ADDENDUM NO. 1 - TO ALL OFFERORS
Reference Request for Proposals (RFP) No. 1980

Title QUEENS LAKE SANITARY SEWER PROJECT – CONTRACT #6 VACUUM LINEWORK
WEST

Addendum No. 1 – February 9, 2016

Queens Lake Sanitary Sewer Project Contract 6 – Vacuum Linework West

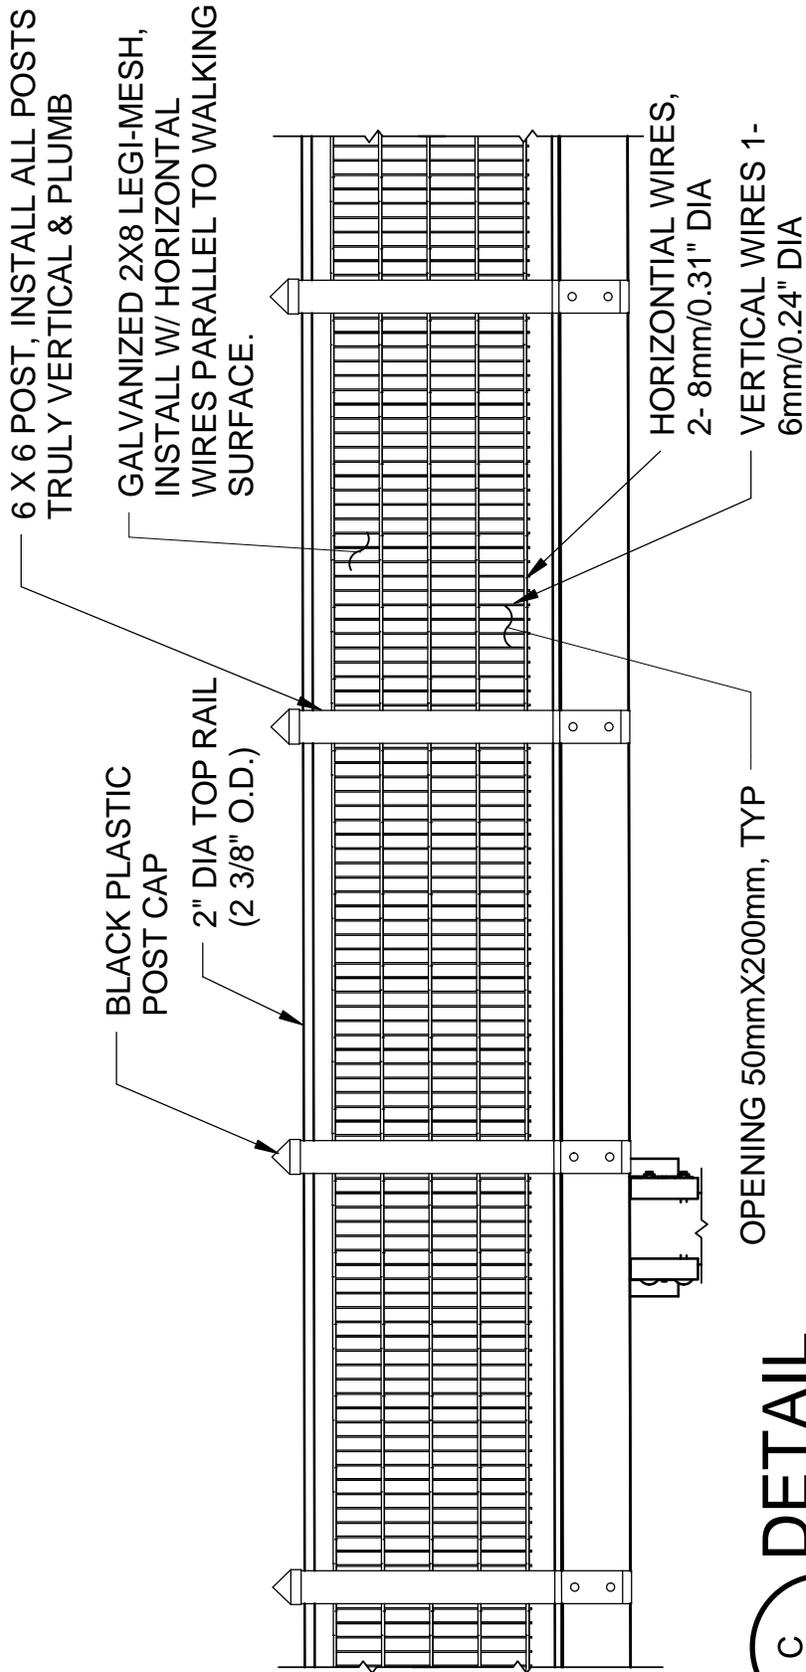
12. Sheet C7 – DELETE lateral stub and end of line marker, and ADD grinder pump and 1-1/2" force main for residence at 111 Saxon Road. Sketch SK-4 is issued with this Addendum.
13. Sheet S9 – REPLACE section for Bents 5 to 34, 36. Sketch SK-1 is issued with this Addendum.
14. Sheet S1.0 – REPLACE Test Pile Program paragraph of Note 28 with the following:

31. On the section for Bent 2 on Sheet S-9, the top rail is shown as being 2" in diameter. The section for Bents 5-35, 36 shows the top rail as being 1-1/4" in diameter. Please clarify the diameter of the top of the rail.
See Sketch SK-1 included with this Addendum.

BENTS 5 TO 34, 36

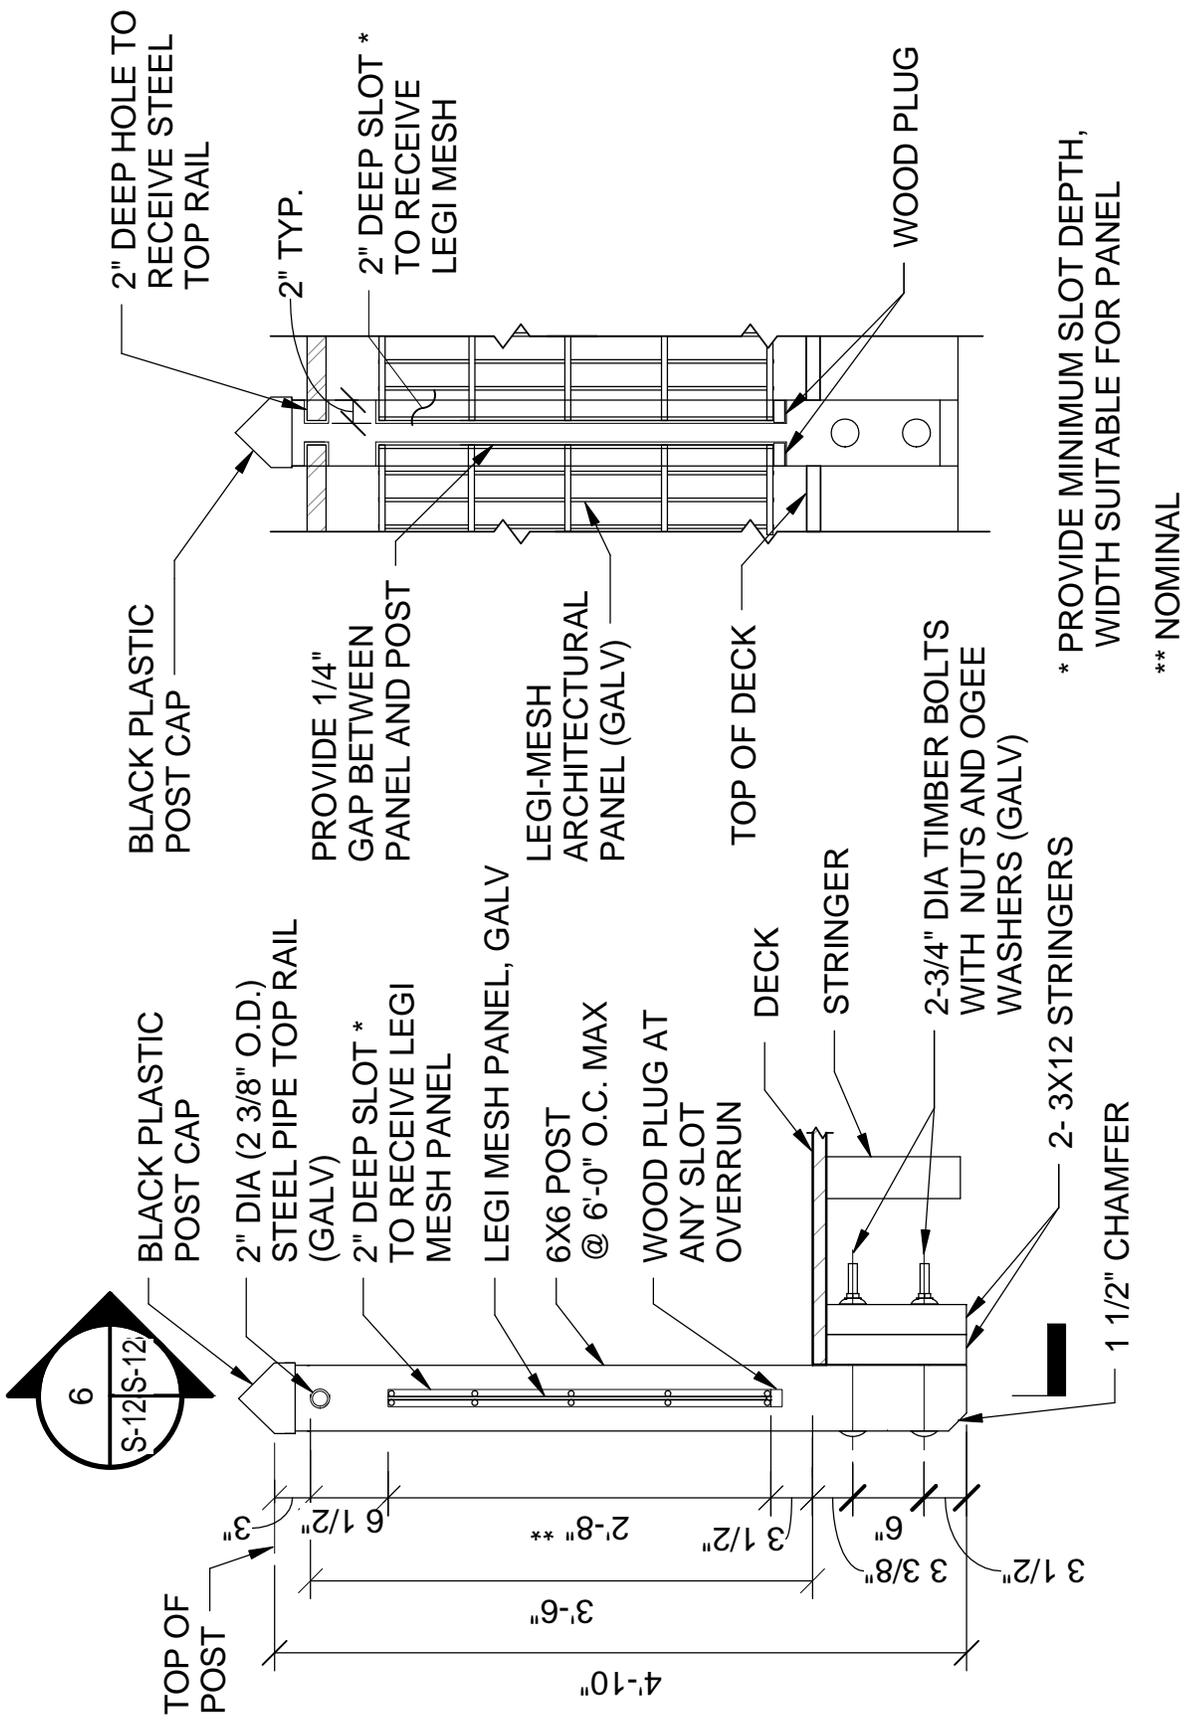
15. Sheet S1.0 – ADD Note 29: “Piles shall be timber without exception.”
16. Sheet S12 – REPLACE Section C. Sketch SK-2 is issued with this Addendum.
17. Sheet S12 – REPLACE Details 5 & 6. Sketch SK-3 is issued with this Addendum.

C
S-12
SCALE: 3/8" = 1'-0"

2" DIA TOP RAIL
 (2 3/8" O.D.)
